From: Nathan Chilvers <nathan@pyrusdesign.com>
Sent: 10 April 2013 13:23
To: Hannah Barker
Subject: 1204 - 12 Norman Crescent - updated drawings
Attachments: 1204 issue sheet 130410.pdf; 1204(21)000B.pdf; 1204(31)000C.pdf; 1204(31)001C.pdf

Please find attached updated plan and elevations to cover recent amendment as requested.

Project title: 12 Norman Crescent, Shoreham by Sea

01 PROPOSED PART GROUND FLOOR PLAN
1:50

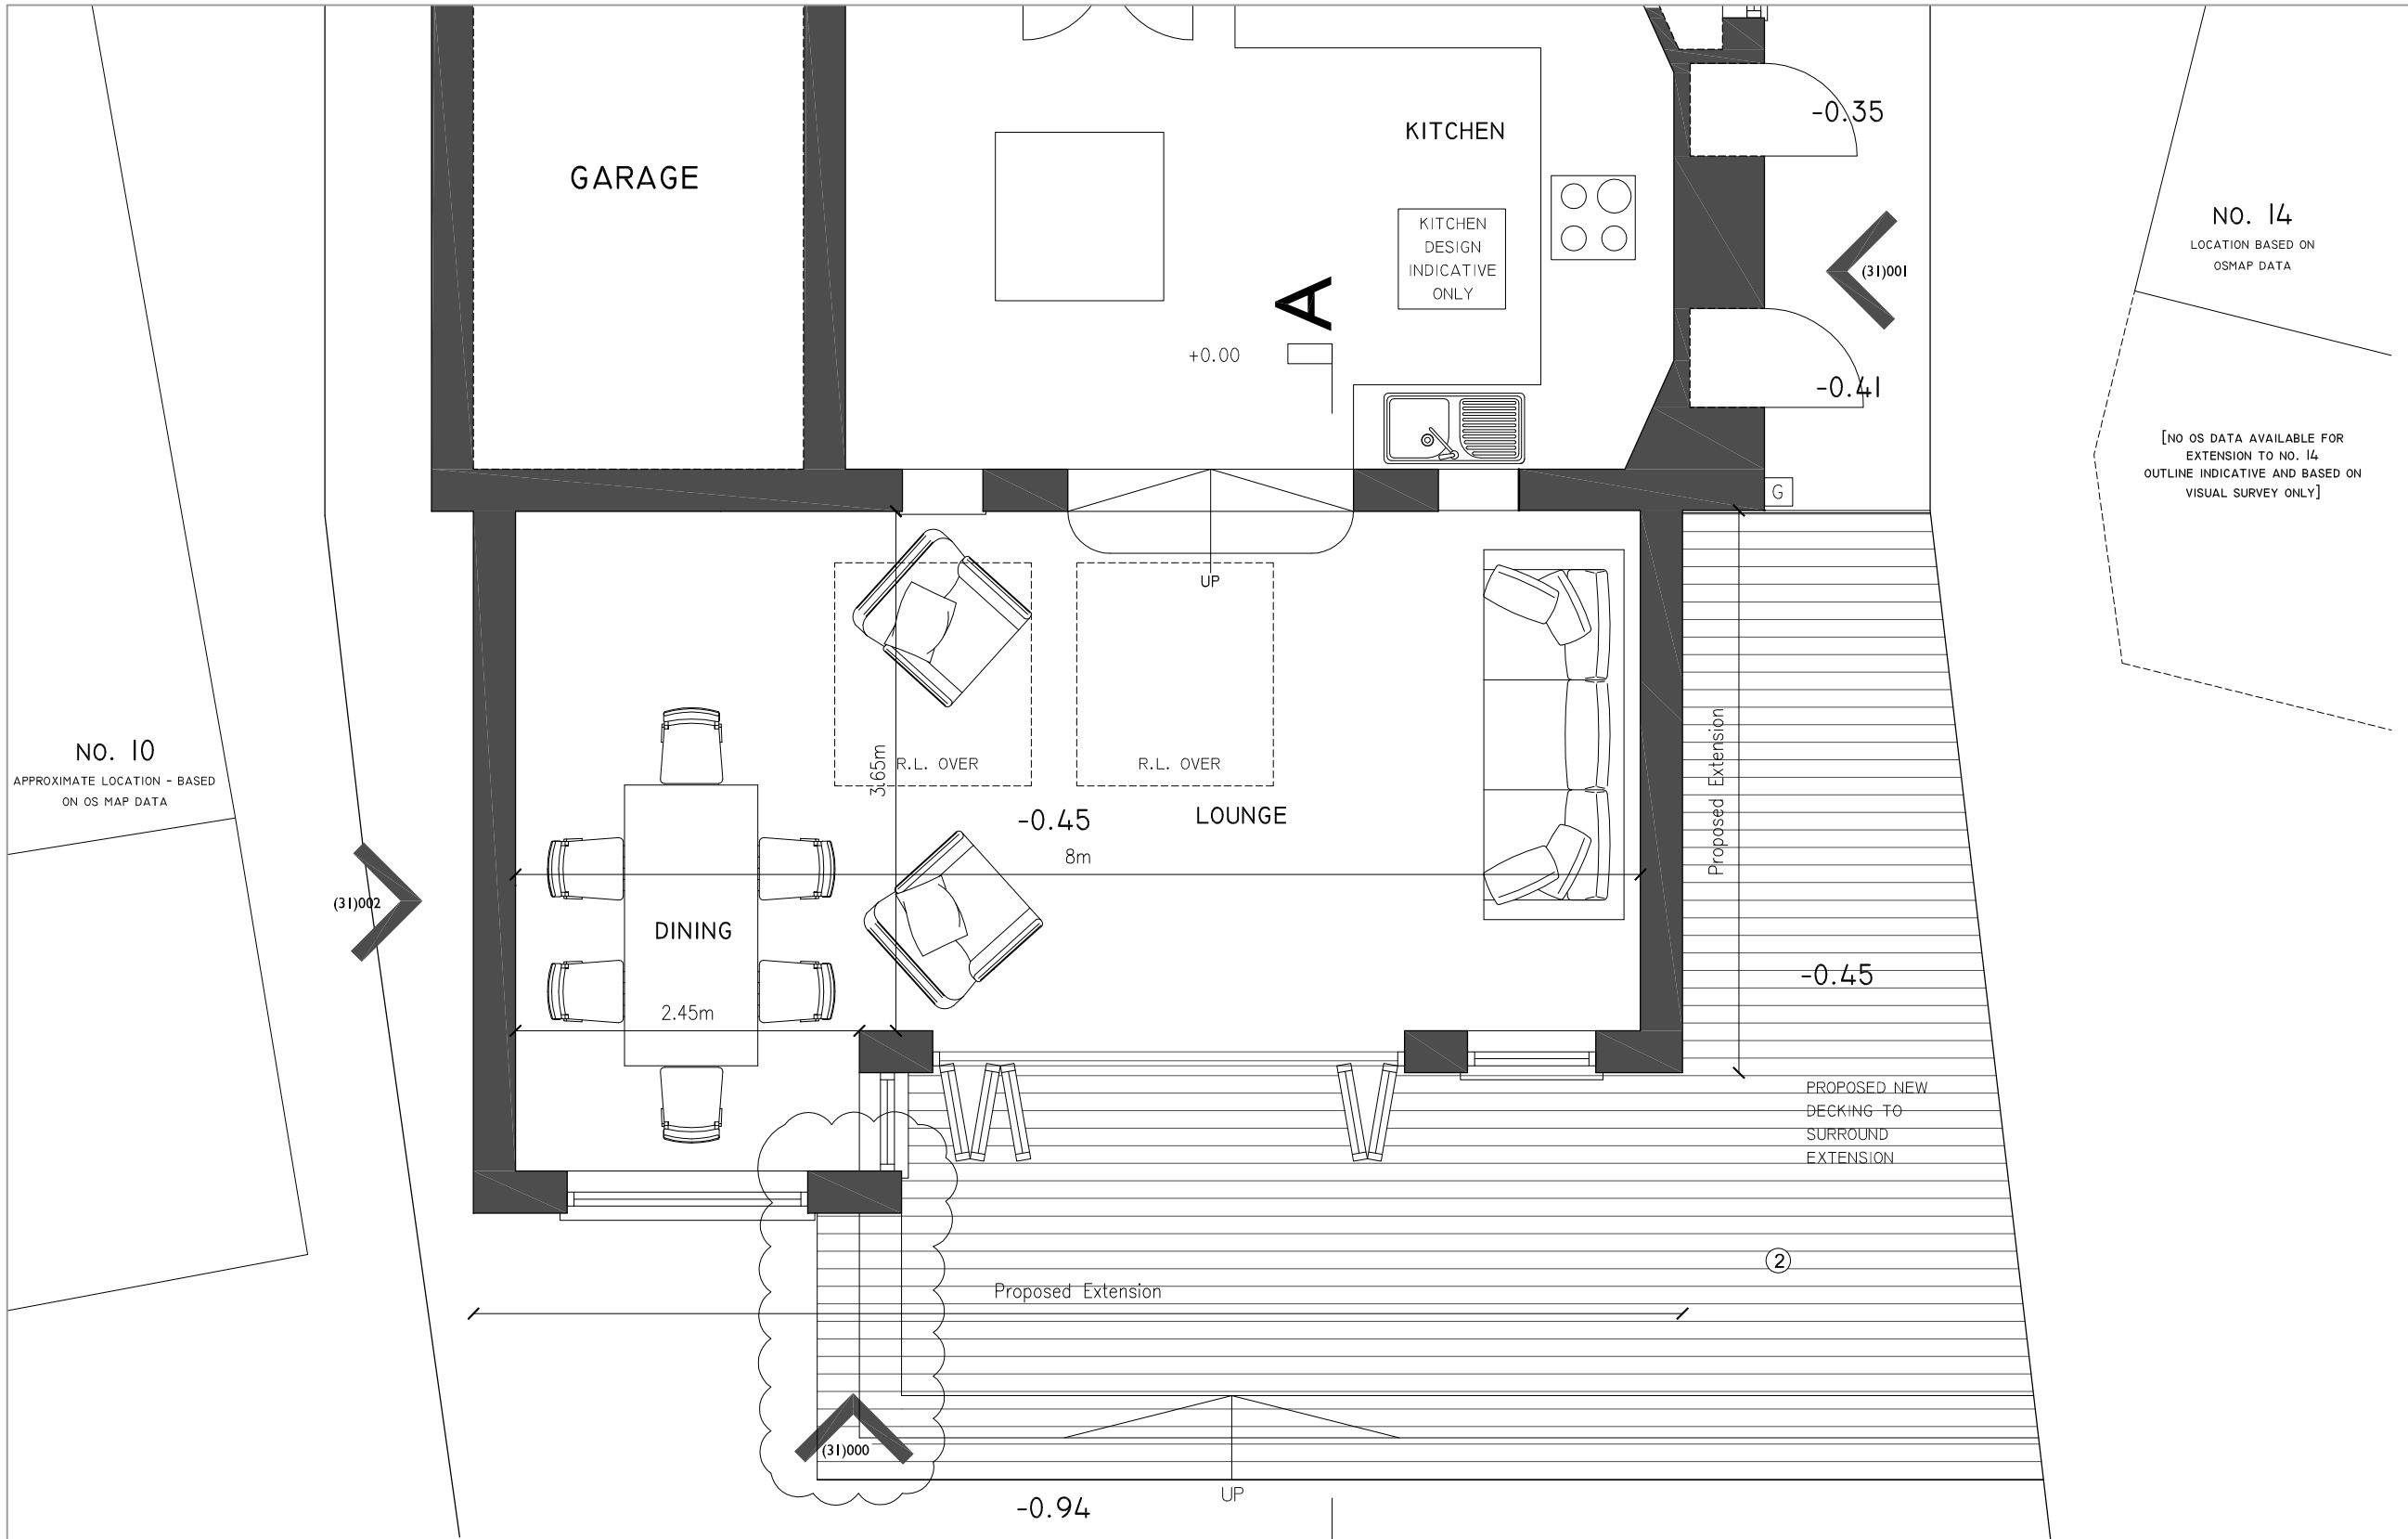
DATE:	REV:	NOTES:
A	08.02.13	Planning Submission.
B	08.04.13	Decking to west side amended at planner request. Kitchen and Lounge locations swapped

01 PROPOSED PART EAST ELEVATION
1:50

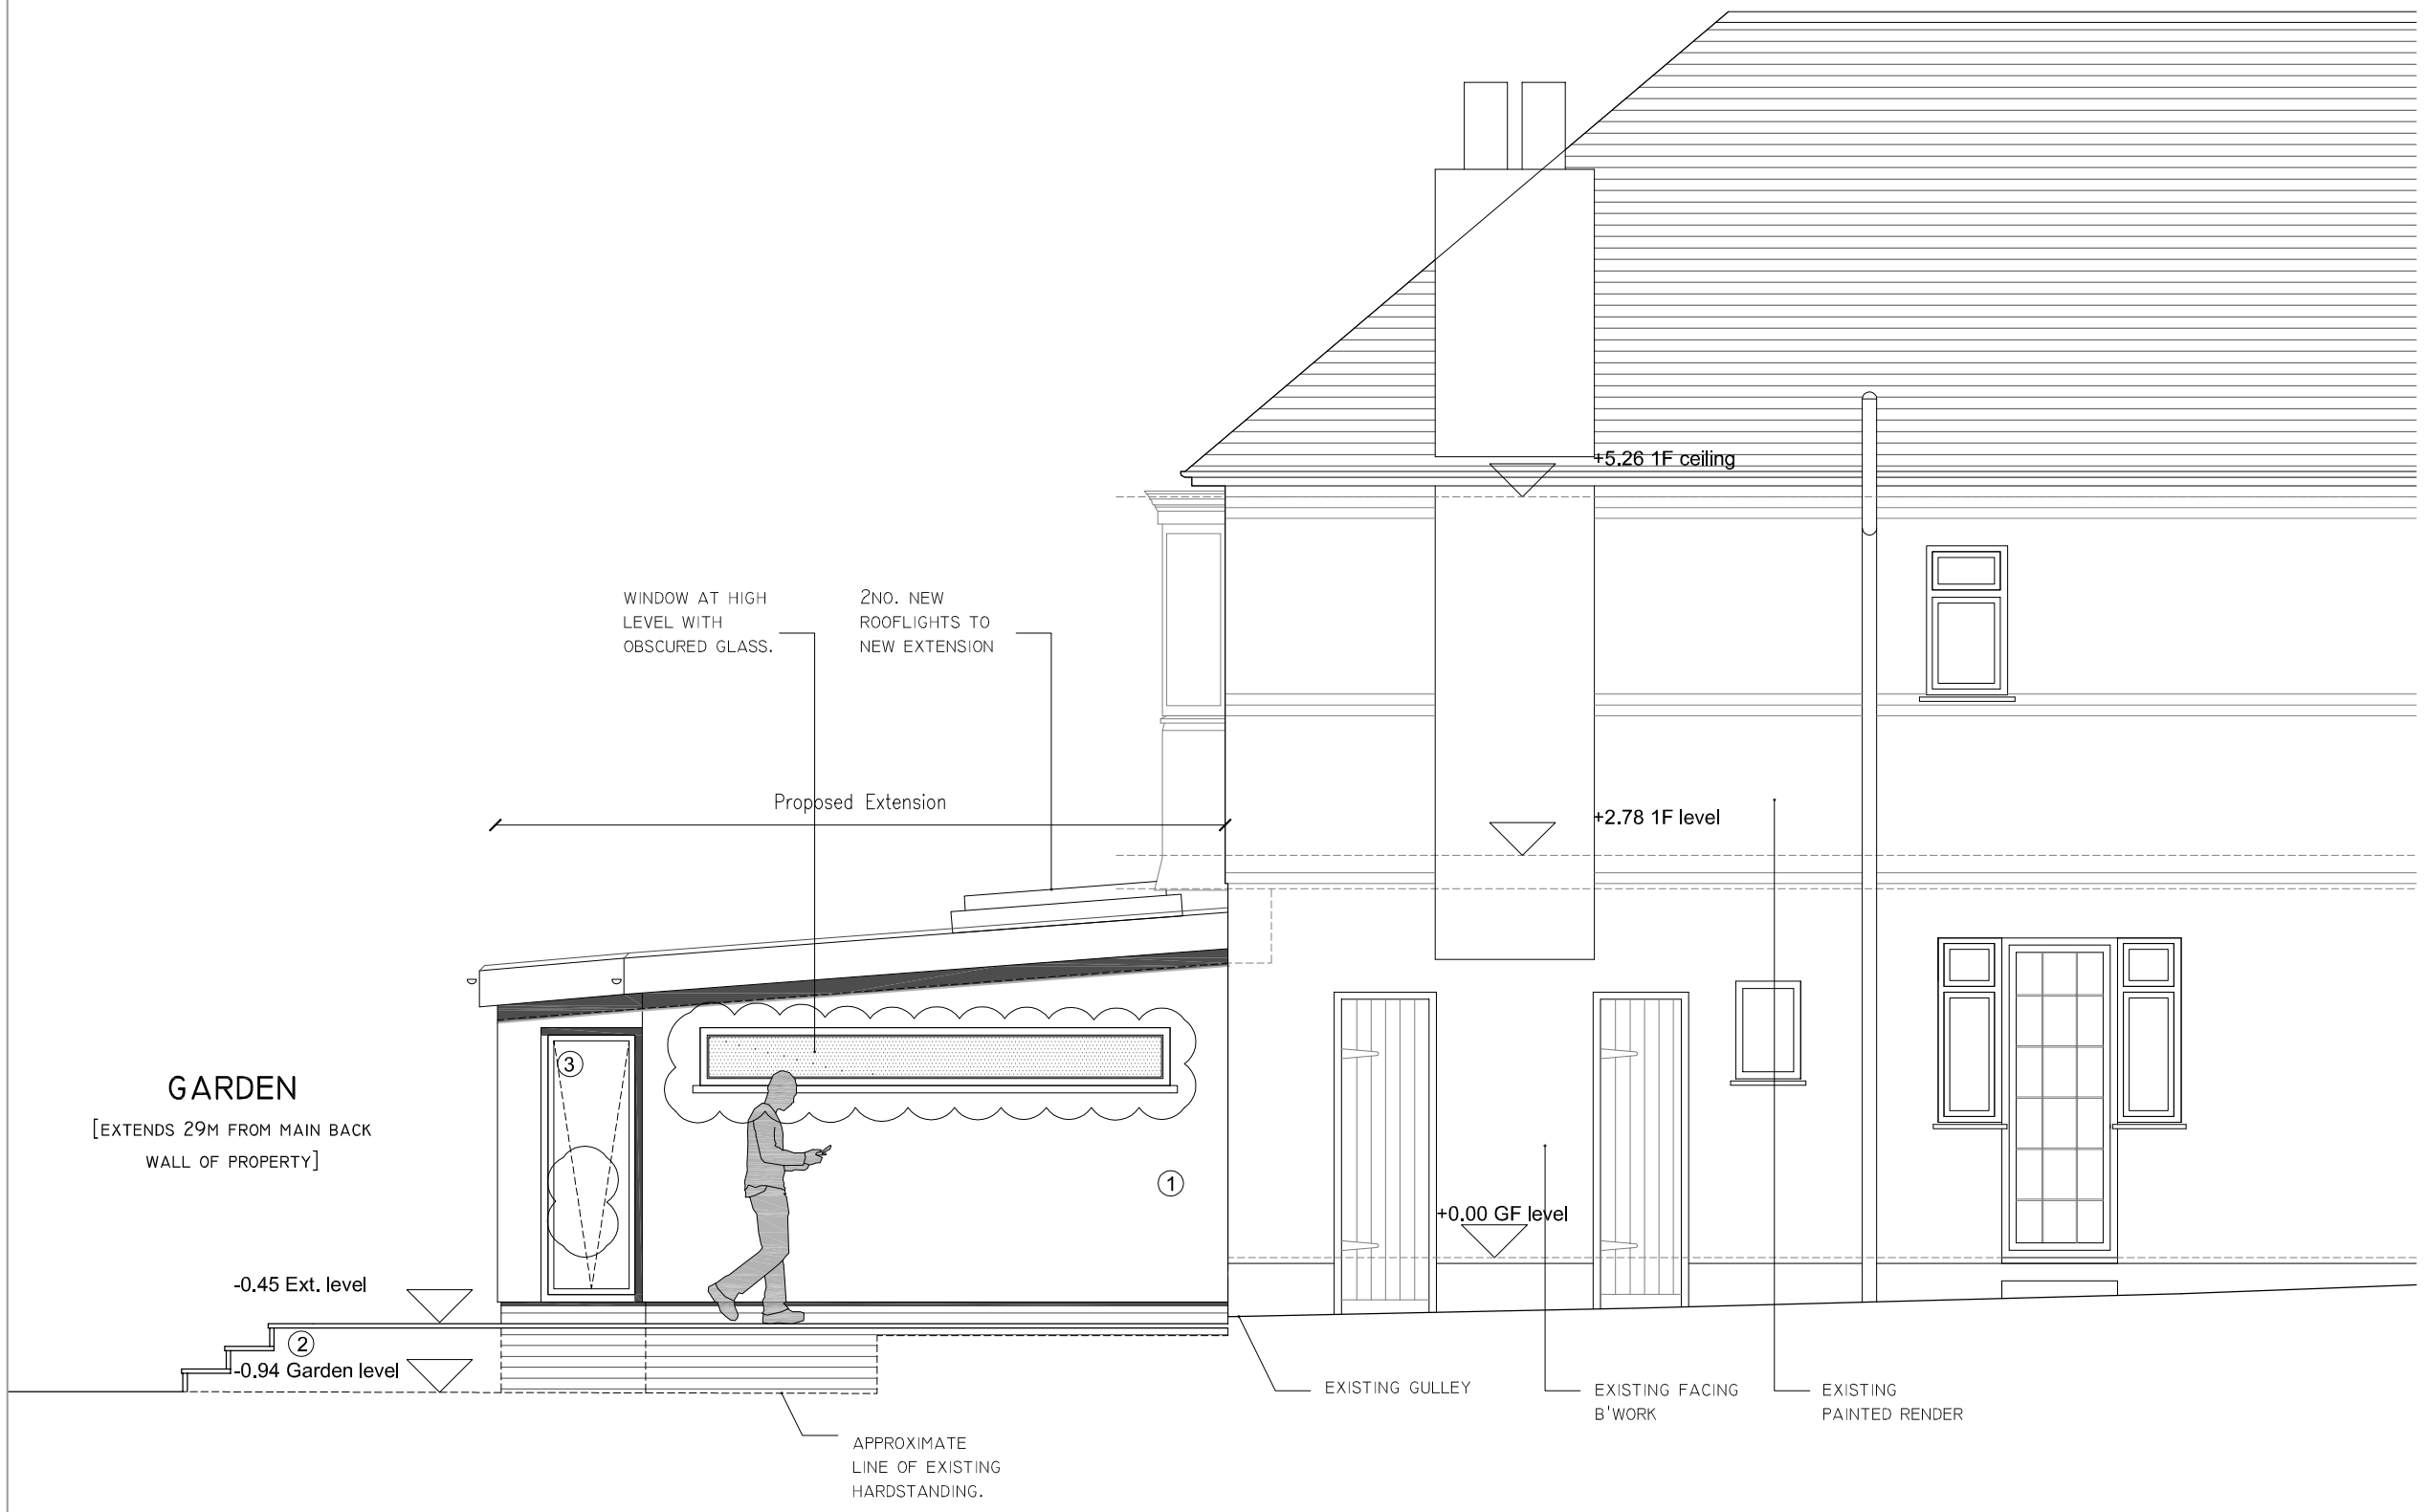
The client has also requested a high level horizontal slot window be added to the east elevation of the extension. This has also been shown in the current drawings and I have noted that it should be obscured glazed so as to avoid any overlooking / privacy issues.

DATE:	REV:	NOTES:
A	08.02.13	Planning Submission.
B	08.04.13	Glazing amendments Drainage items removed.
C	09.04.13	High level window to east added at client request.
